ORDINANCE NO. 2013-056

AN ORDINANCE GRANTING CERTAIN APPROVALS FOR THE SPRINGS OF VERNON HILLS GENERALLY LOCATED ON THE WEST SIDE OF MILWAUKEE AVENUE AT THE INTERSECTIONS OF NORTH AND SOUTH WOODBINE CIRCLE IN THE VILLAGE OF VERNON HILLS, LAKE COUNTY

Department of Community Development  
**TECHNICAL REVIEW COMMENTS #2**  
**FOR**  
**SPRINGS OF VERNON HILLS**  
**October 25, 2013**

**STORM SEWER AND GRADING PLAN**  
**SPRINGS OF VERNON HILLS**  
**ROUTE 21 (MILWAUKEE AVENUE)**  
VERNON HILLS, ILLINOIS

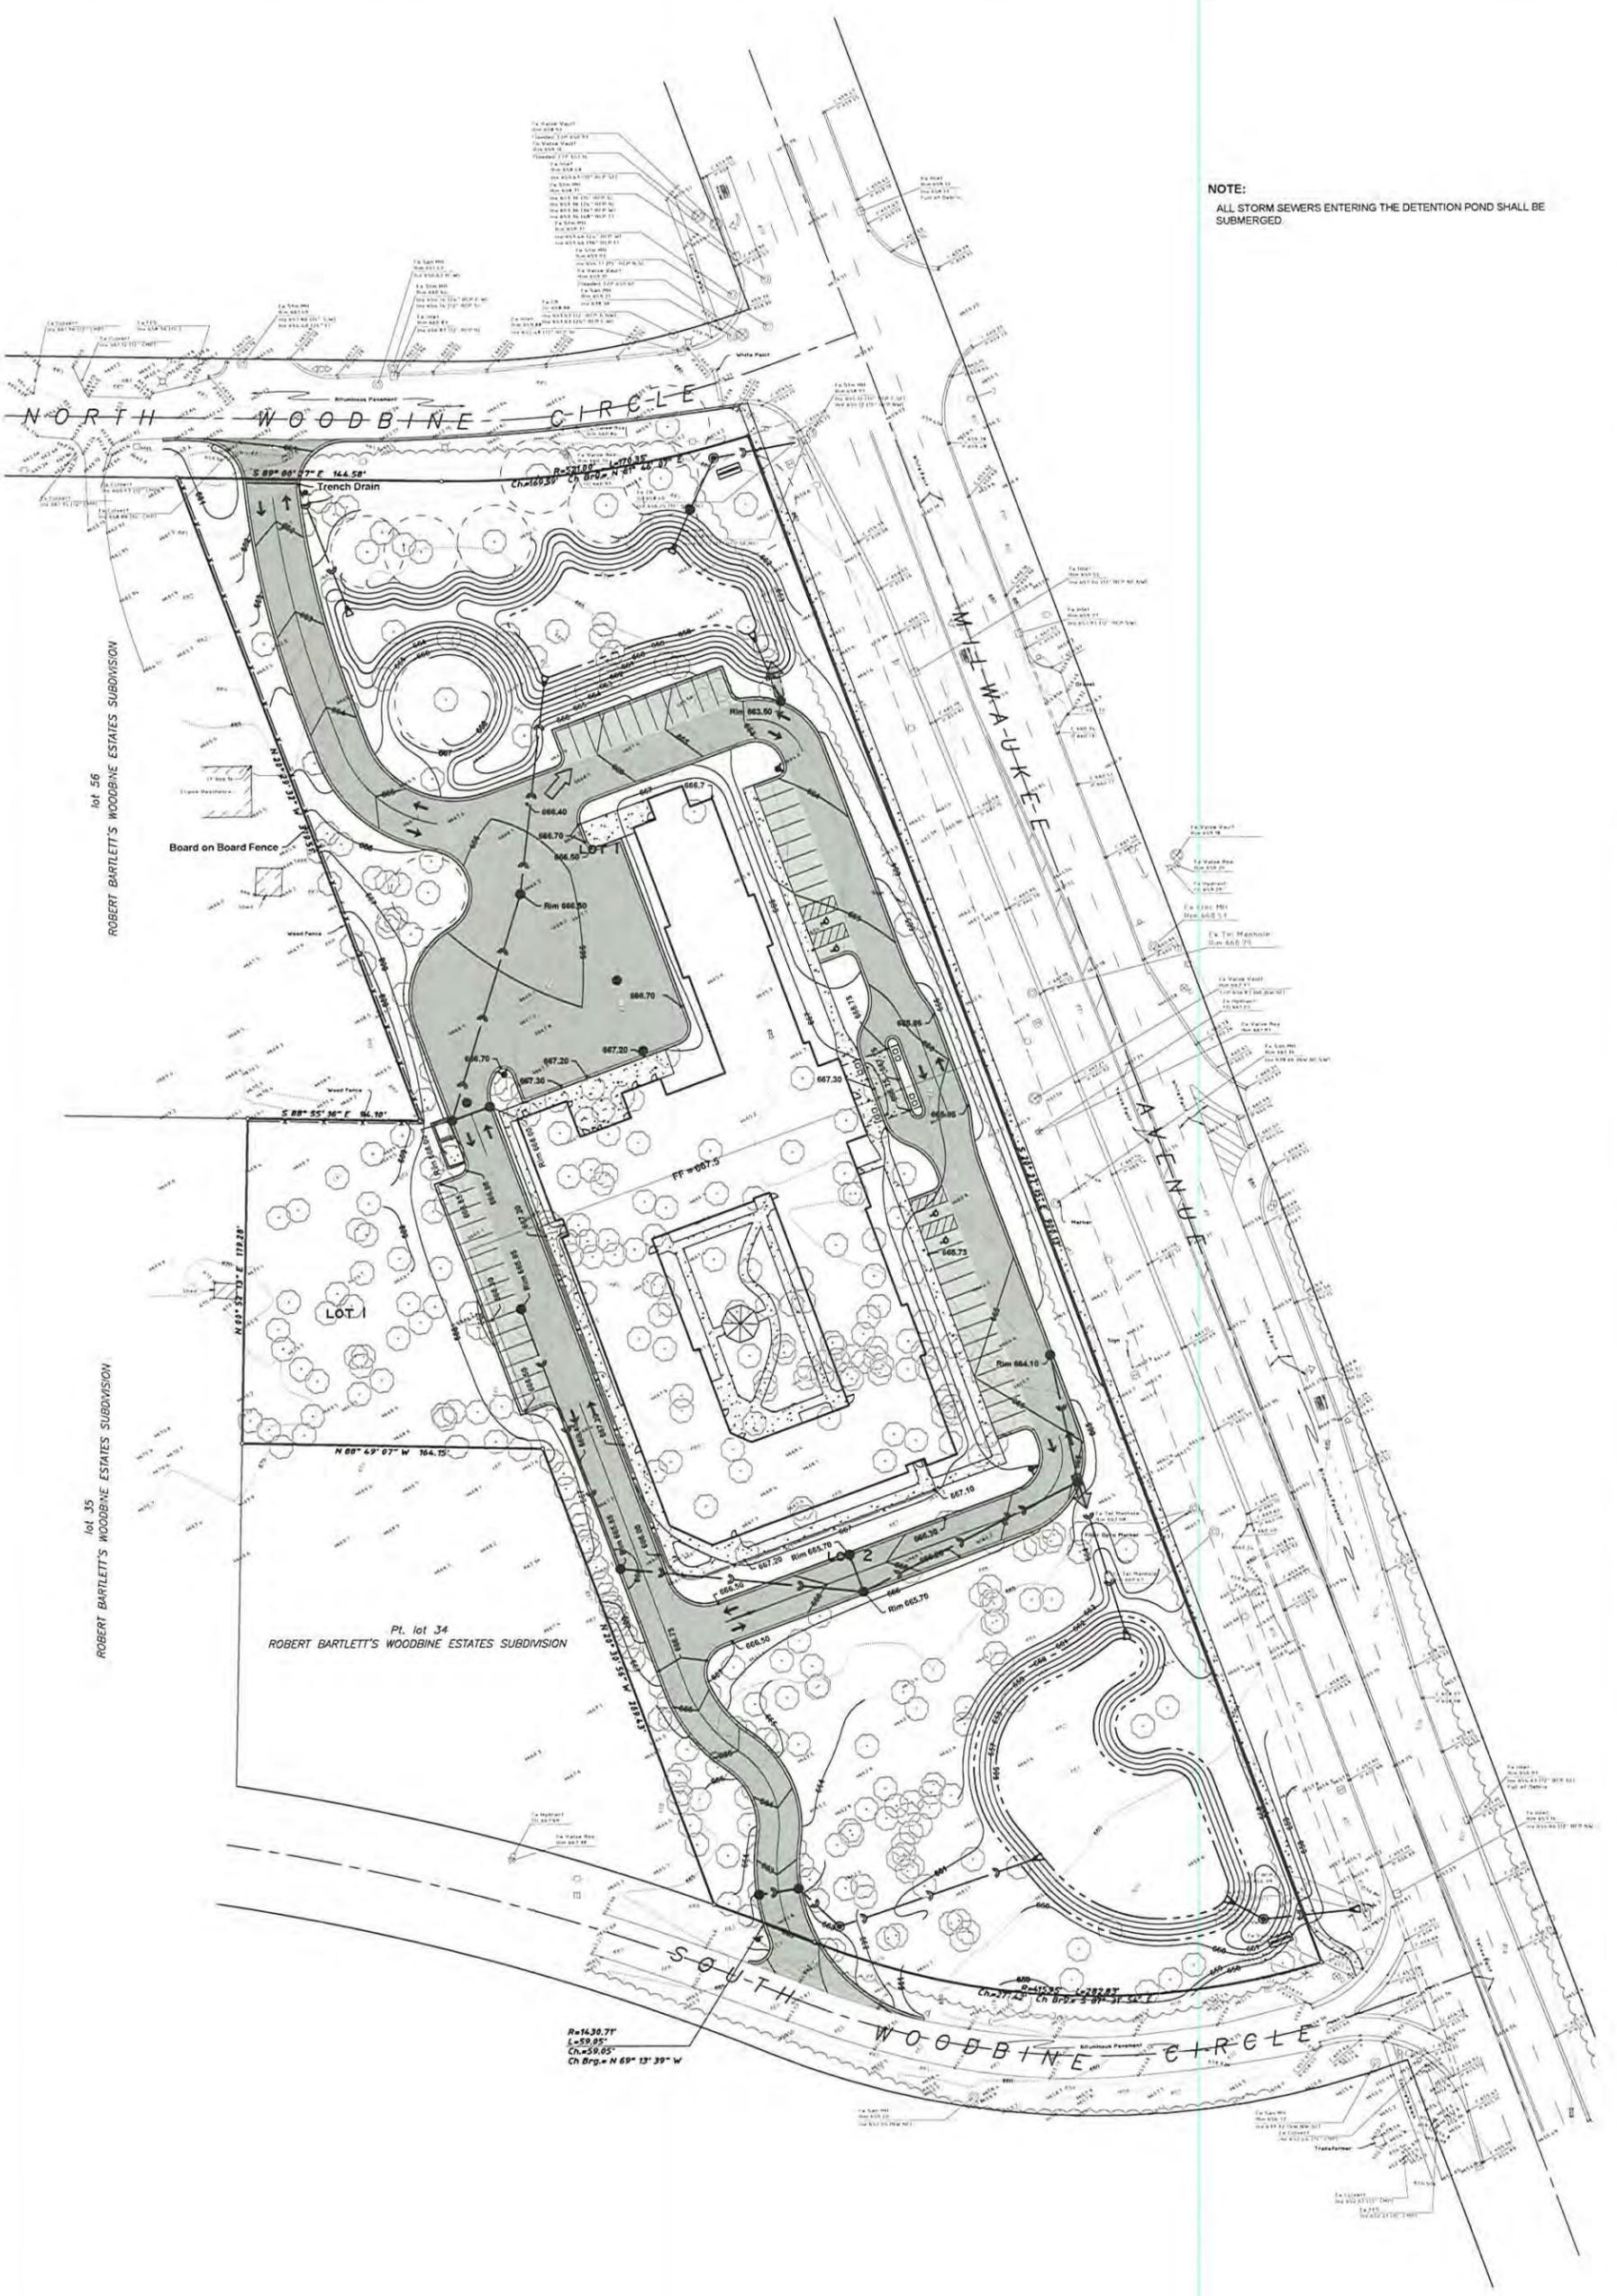
1. Submit full Civil Engineering plans that include all of our comments referenced in this latest submittal.  
*Full Engineering plans will be submitted prior to moving forward with final approval of the site.*
2. All proposed pipe into the ponds shall be submerged. Outlet pipes shall be Flared End Sections.

*A note has been added to sheet 3 regarding the storm sewers entering the ponds being submerged and they will be designed that way during the development of the final plans.*

**TREE PRESERVATION PLAN**  
**SPRINGS OF VERNON HILLS**  
**ROUTE 21 (MILWAUKEE AVENUE)**  
 VERNON HILLS, ILLINOIS

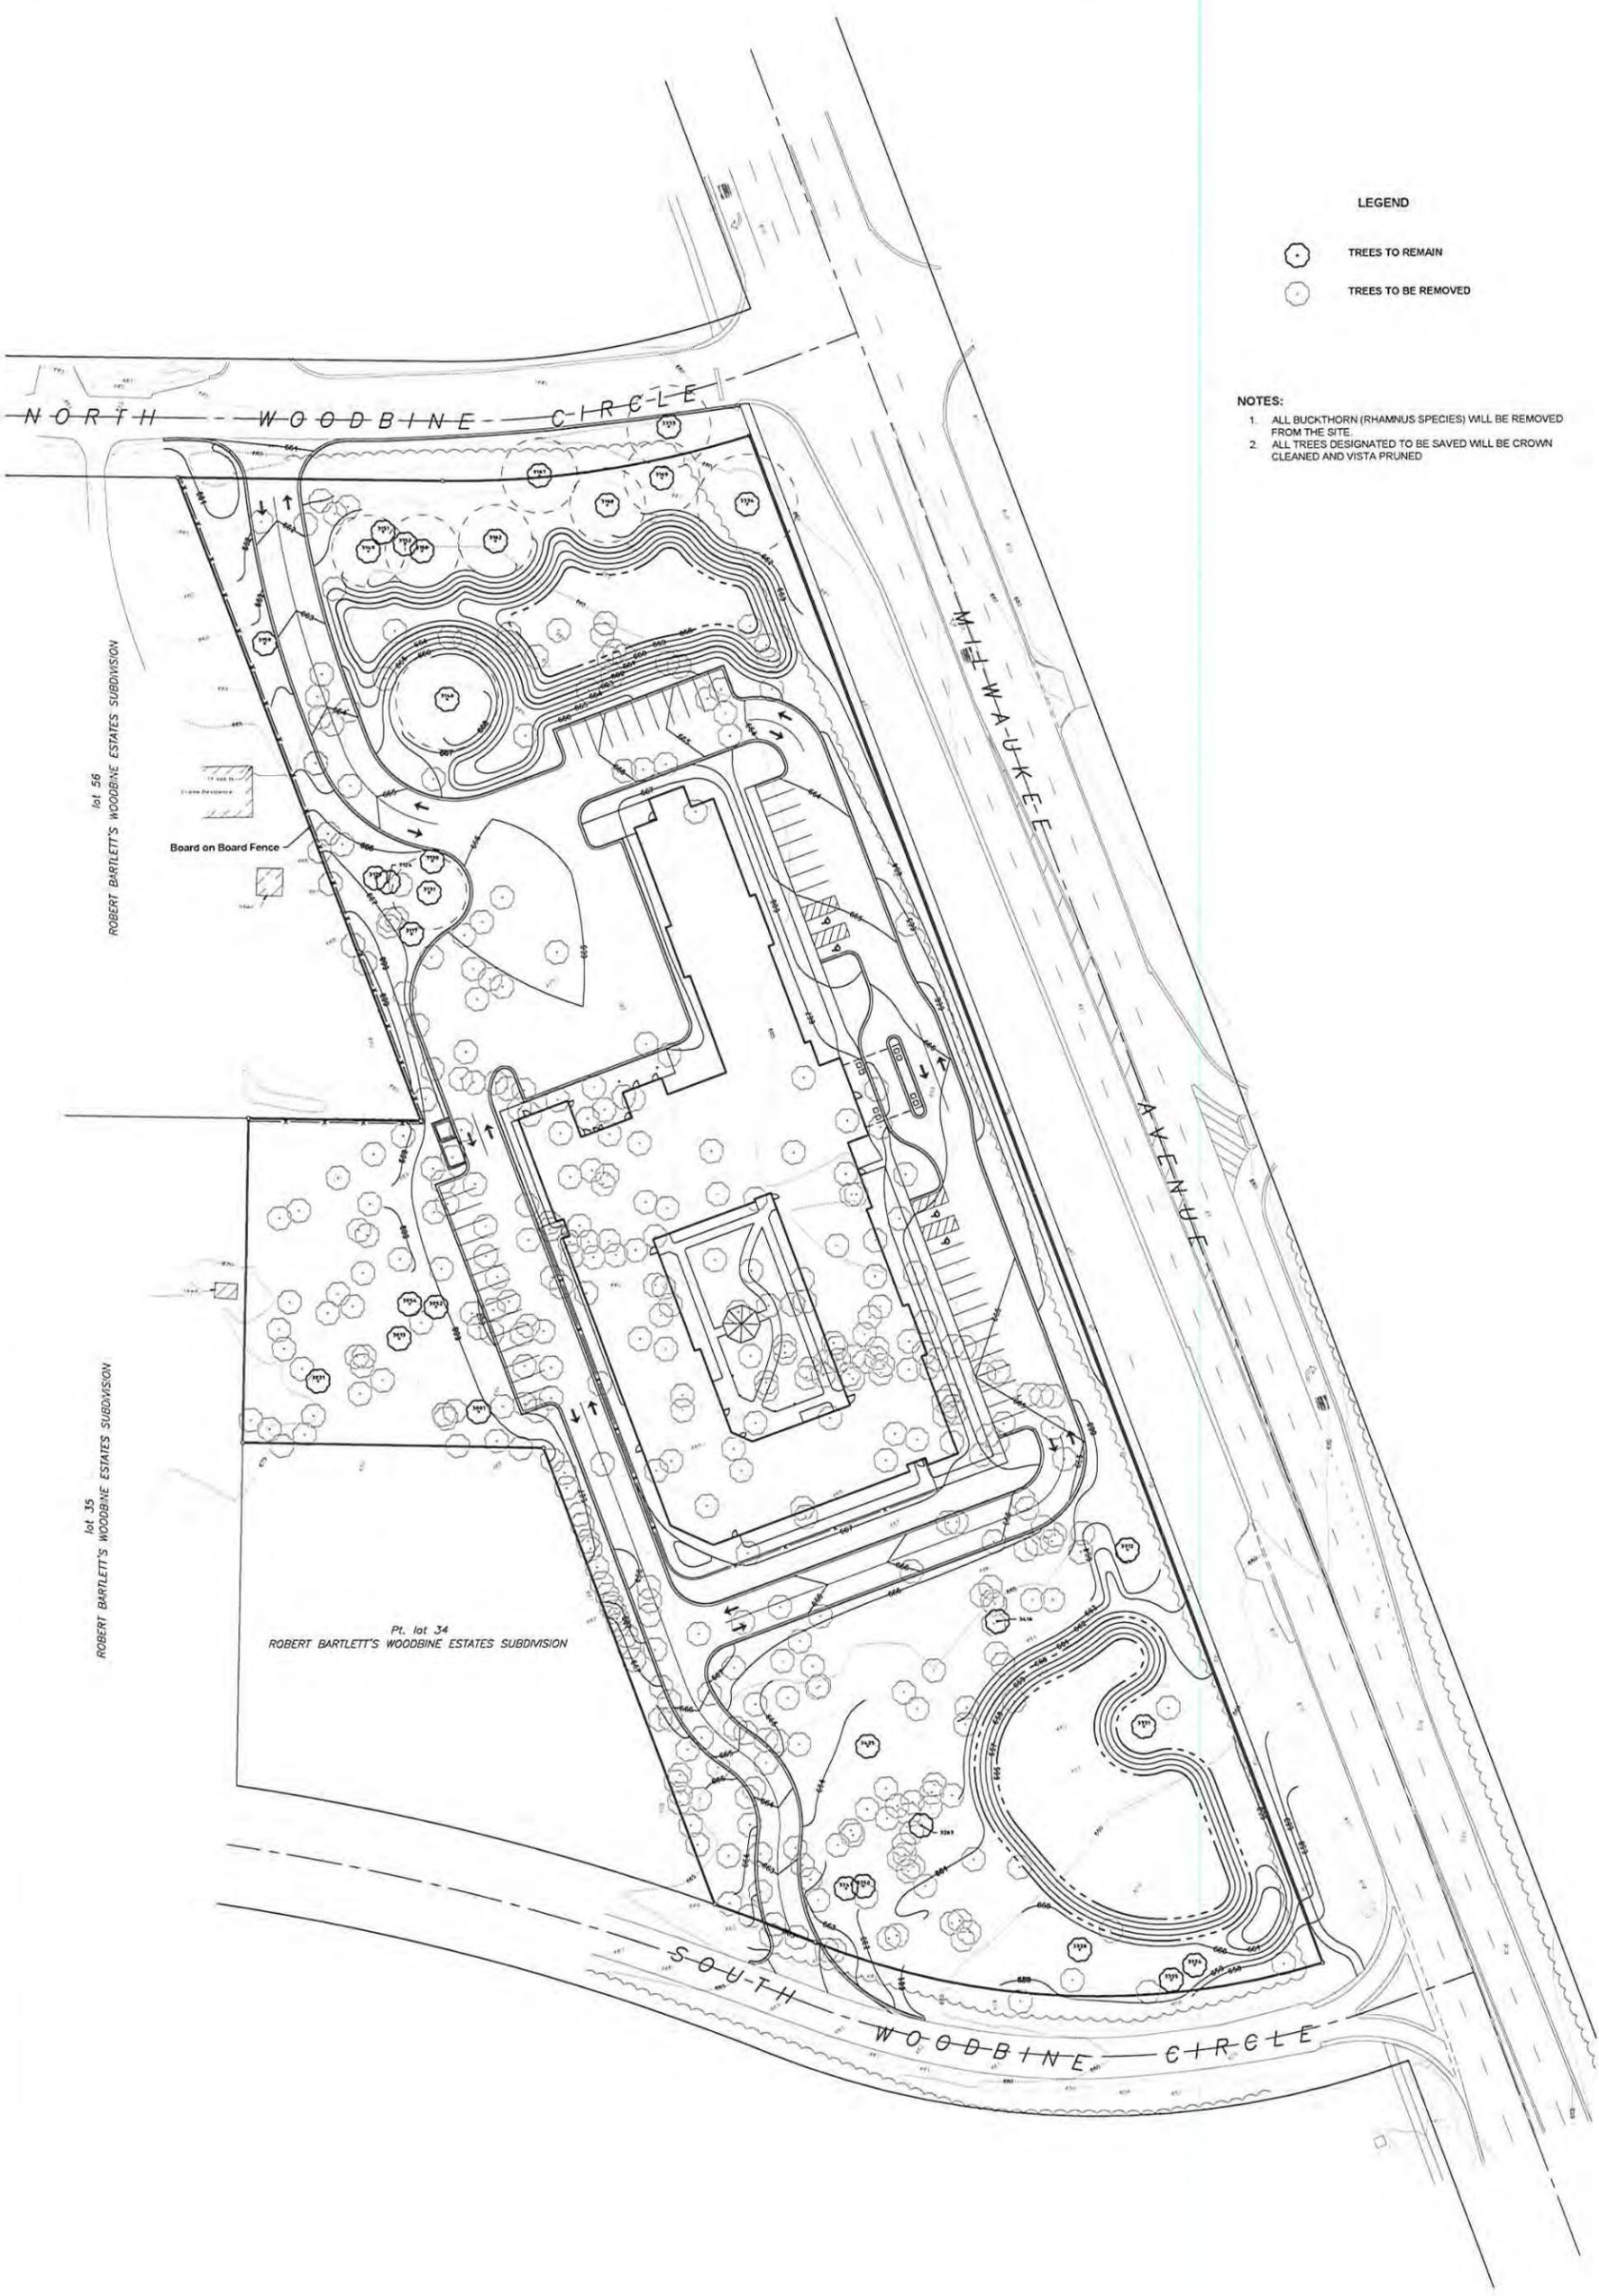
1. I recommend that any tree being designated to be saved that is in a "poor condition" be removed. It is better to clean it up now rather than being a maintenance issue later.

*All trees that were being saved and were in poor condition are now being removed as recommended.*

Sheet Title  
PRELIMINARY ELEVATIONS

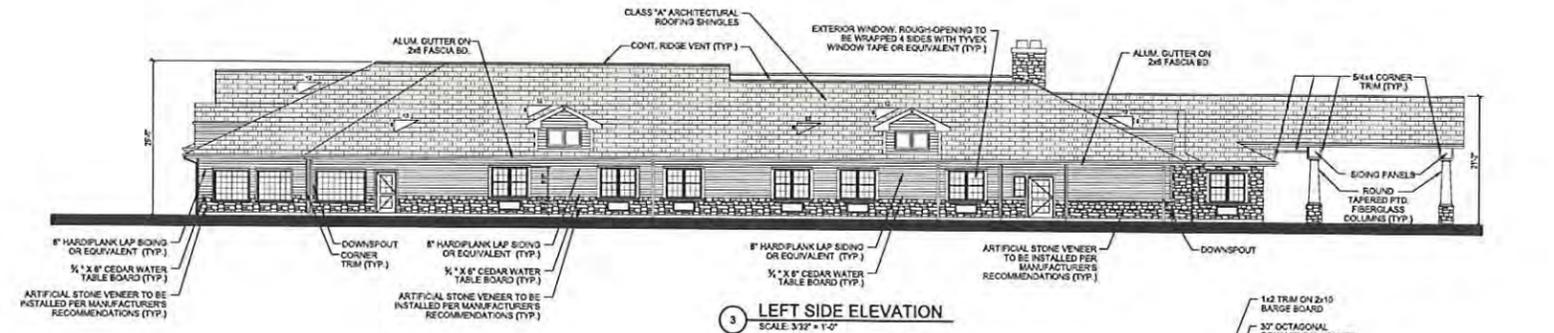
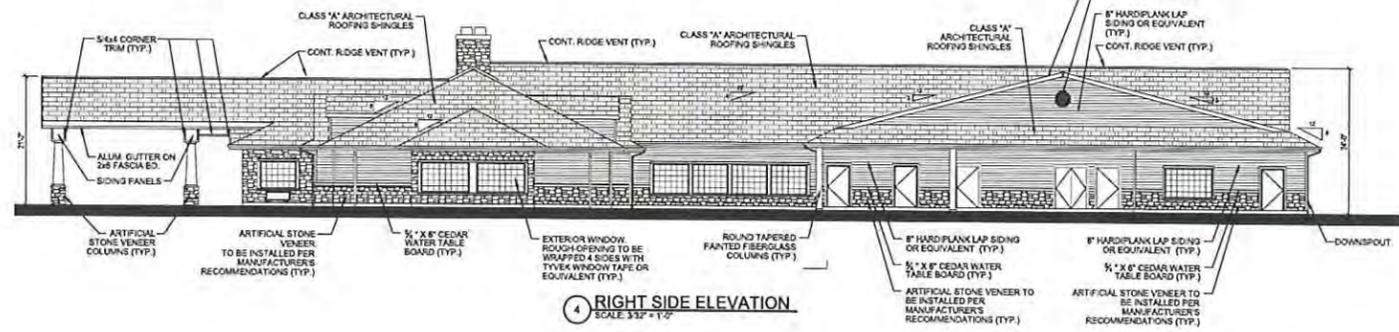
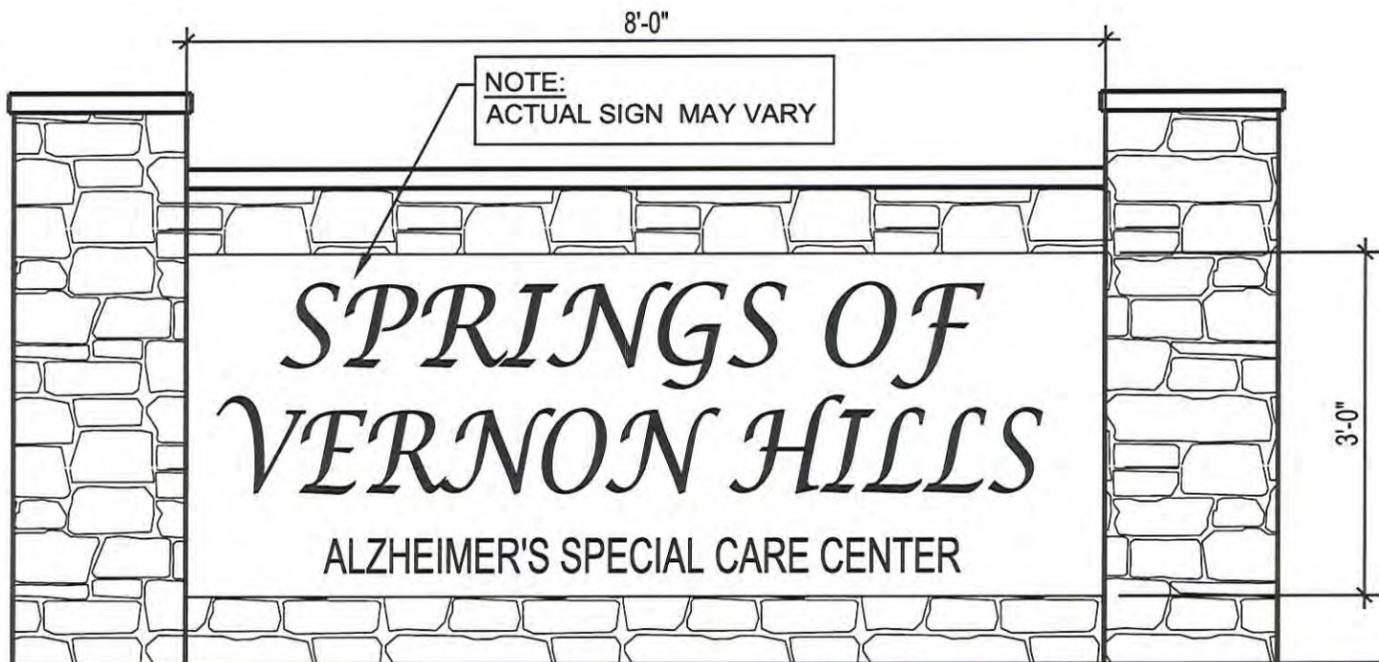
- **The exterior wall finished on the back and side elevations shall include stone veneer and be consistent with the design of the front elevation.**  
*Stone Veneer has been added to the back and side elevations. Please refer to the revised Exterior Elevations drawing dated 10.31.13.*
